Working Instruction

Working Instructions

Group 03/1

MB 100 Series Installation of Dual Mass Flywheel For OM 662 Engine Only

Figure 1

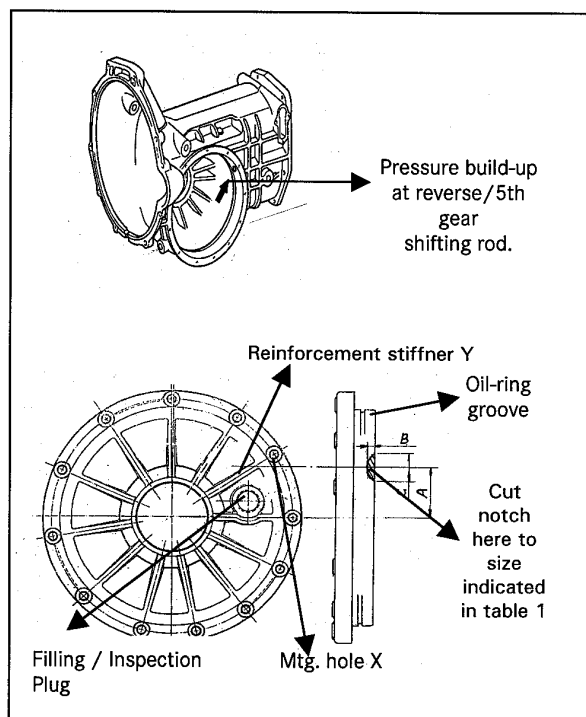
1. First remove left side drive shaft & axle assembly as detailed in repair instructions microfilm 33-1265.
2. Drain out transmission fluid.
3. Remove differential cover
4. Remove shaft seal & O-ring.
5. Place the cover on a worktable with its internal surface pointing upwards. Locate the cover reinforcement stiffner Y that is between the filling /inspection plug & the mounting hole X.
6. Mark the notch outlines with one end aligned with stiffner Y as shown in Figure 2. The depth & width is indicated as A & B in Table 1.

Ensure the notch is not cut too deep as it will interfere with the O- ring groove.

(Figure.1)

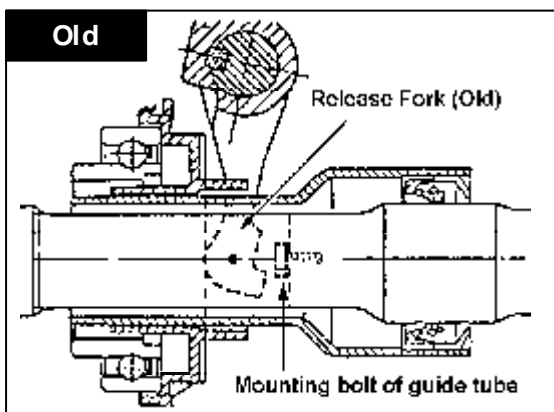
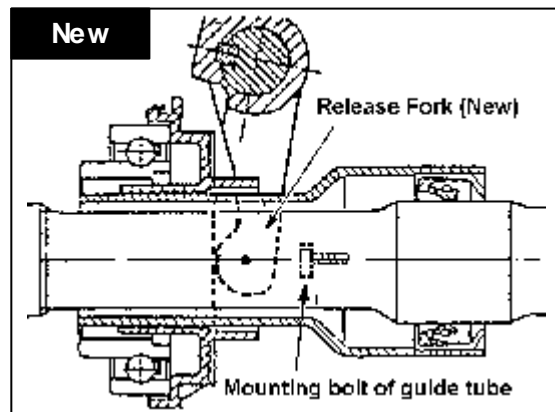
■ **Production remedy** : Clutch release fork was changed from January 1998, Chassis number 061110~

■ **Service remedy** : In case of premature wear of clutch disc under normal operation, clutch release fork should be checked. It is possible to check the clearance between the release fork and the mounting bolt of guide tube before remove transaxle.

(Figure.3)

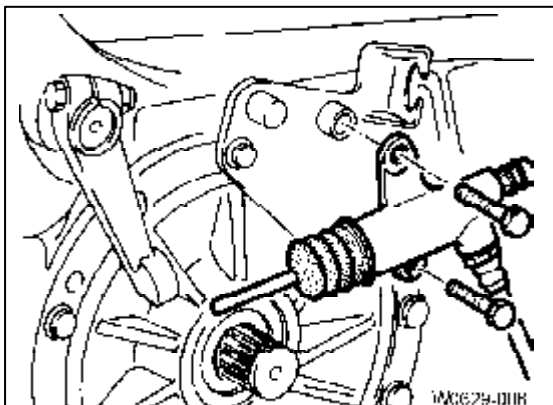
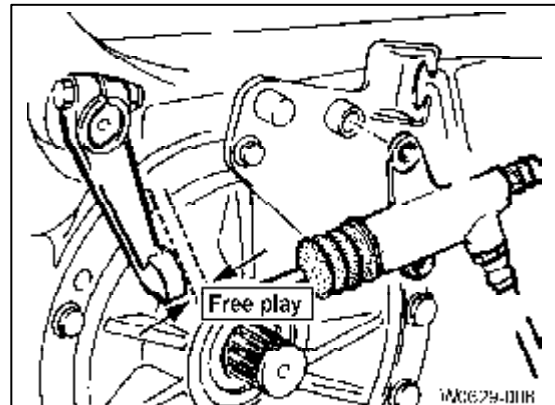
- 1) Remove the clutch sleeve cylinder. (refer to Figure.3)
- 2) Check the free play of release lever. (refer to Figure.4)

If there is no free play, release fork might touch the mounting bolt of guide tube. Then remove the transaxle. If you find out an extension at the back of arm of the release fork touching the head of mounting bolt of guide tube, the release fork should be replaced by new one. (Part no :661 293 3111)

Figure 1

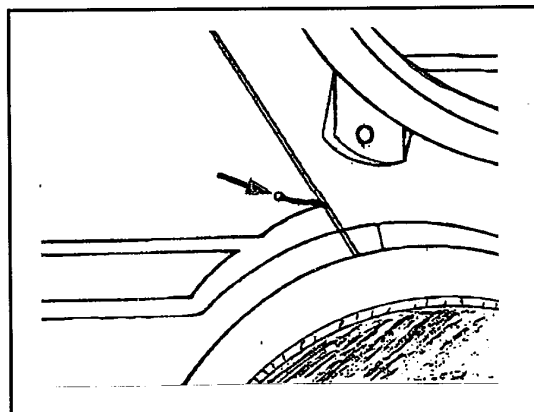
1. Drill a $\varnothing 2.0$ mm bore at the end of the crack in order to stop the crack from developing further.

Refer to arrow of figure 1.

Figure 3

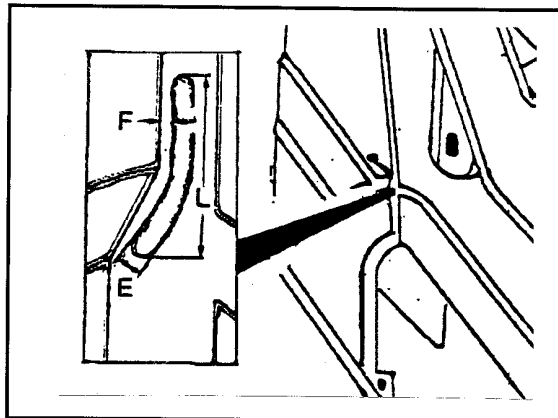
Refer to figure 3.

F = approx. 0.5 mm

Figure 4

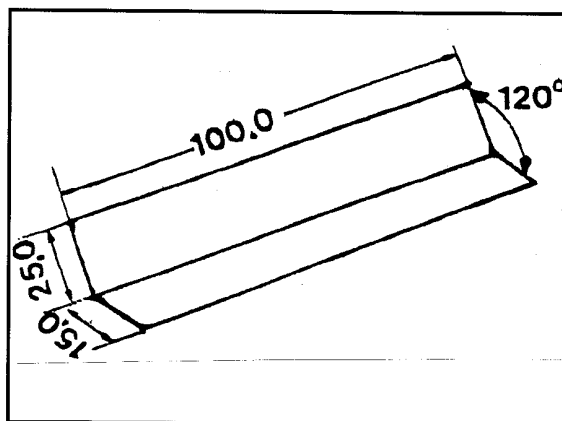
4. Cut a piece of 2.0 mm thick sheetmetal plate to the size of 40.0 mm x 100.0 mm. Form the plate according to the shape of the outer body panel. Bend the plate by 120° a distance of 25.0 mm from one edge approximately. Treat the plate with zinc primer suitable for spot welding.

Refer to figure 4.

Figure 5

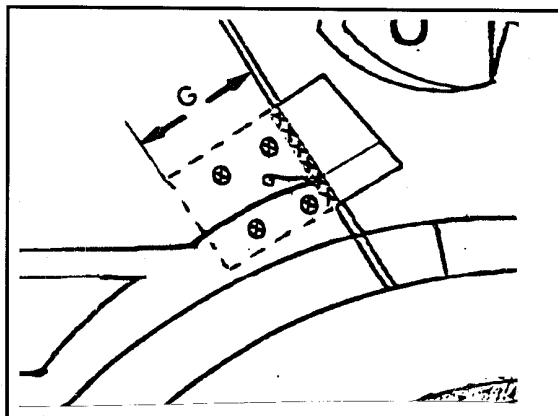
5. Using a hot air blower, warm up the whole area of repair in order to separate the hollow cavity foam from the outer body panel. After warm up, insert the plate into the slot to a depth (G) of approximately 55.0 mm – 60.0 mm and fix it tight below the crack. Weld the outer body panel and the plate together by closing the four $\varnothing 5.0$ mm bores and the edge (x). Weld the crack close.

Refer to figure 5.

< Old belt pulley tightener assembly- 5 >

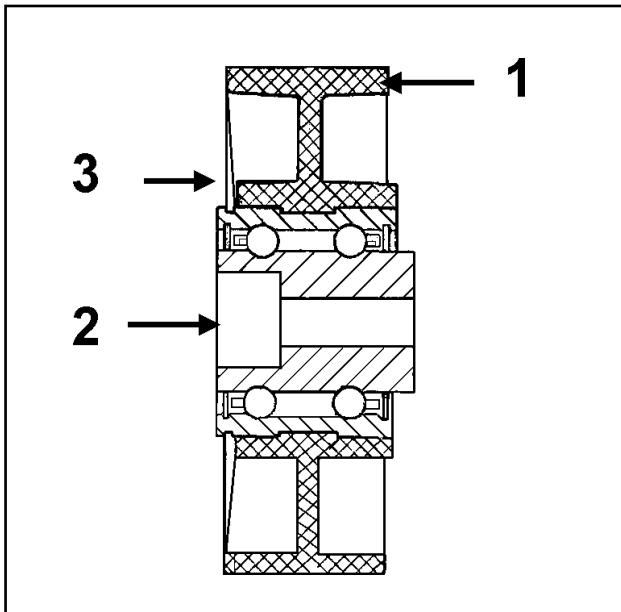
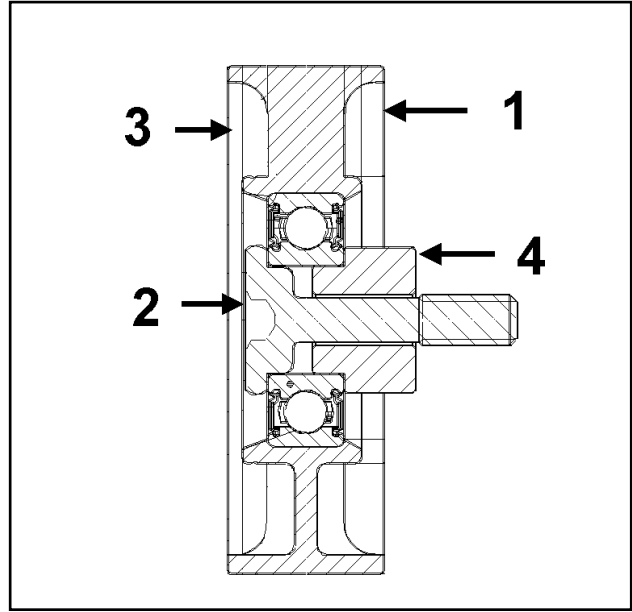
The new belt pulley tightener assembly was introduced to the all MB100 Series with Diesel engine from VIN 73875 onwards, the individual parts of belt pulley tightener assembly are not interchangeable.

Service remedy : In case of installing or replacement, only the **new** belt pulley tightener assembly including idler pulley cover can be adopted. (refer to workshop manual 13-3200)

3 The idler pulley spacer, 661 201 31 50 is added to compensate the width difference between old and new belt pulley tightener.

Figure 1

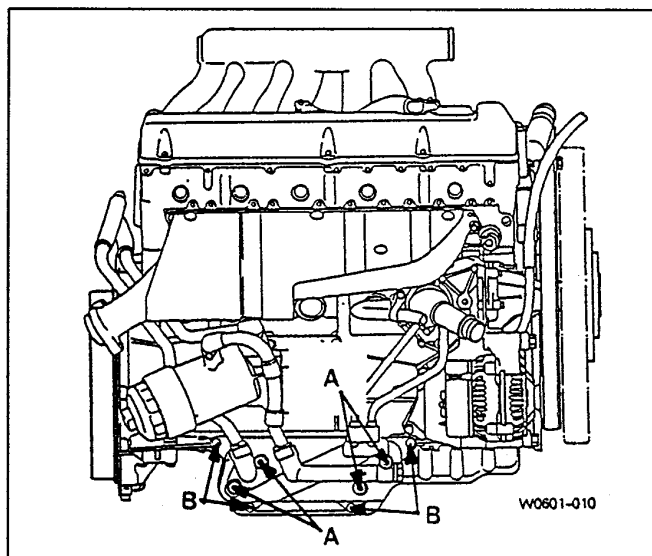
We would like to inform you about the different mounting bolts/nuts at the engine oil-cooler, in order to prevent further oil cooler subject to incorrect repair.

For removing the complete Oil - cooler, only slacken the four mounting bolts " B " crosswise ! (see figure 1).

For installing the complete Oil - cooler, only tighten the four mounting bolts " B " crosswise in steps up to the final torque of 25 Nm. (see figure 1)

Figure 1

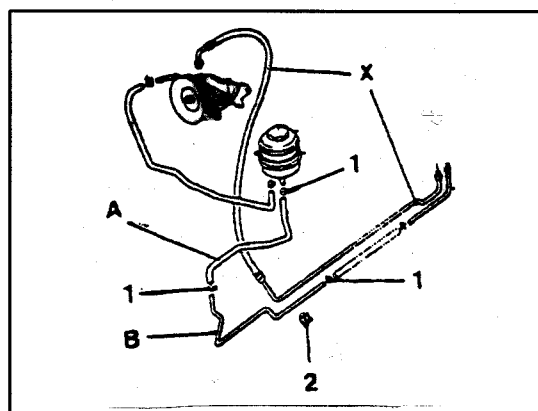
1. Drain steering oil out of the system, into a suitable clean vessel, refer to workshop manual 46- 3415/1.
Remove the three hose clamps (1) of the return pipes/hoses (A and B). Remove hose pipe (A) and return (B). Check pipe clip (2) for damages, if necessary replace.
(Refer to figure 1)

Replace the old oil pressure hose (X) by the new one, spare part no. 661 997 82 82

Figure 2

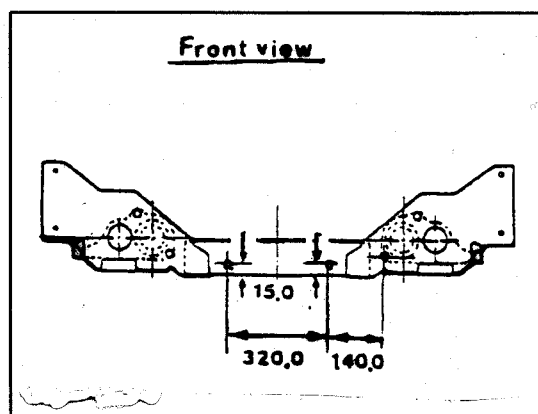
2. Mark both bores to be drilled according to the drawing and measurements given in figure 2.
From the lower cross member edge-to the centre of both bores = 15.0 mm
From the right inner cross member mounting bore centre- to the right side bore centre = 140.0mm
From the right side bore centre -to the left side bore centre = 320.0mm

Install both riveting nuts no. 99218-08500 with a riveting tool into the new bores.
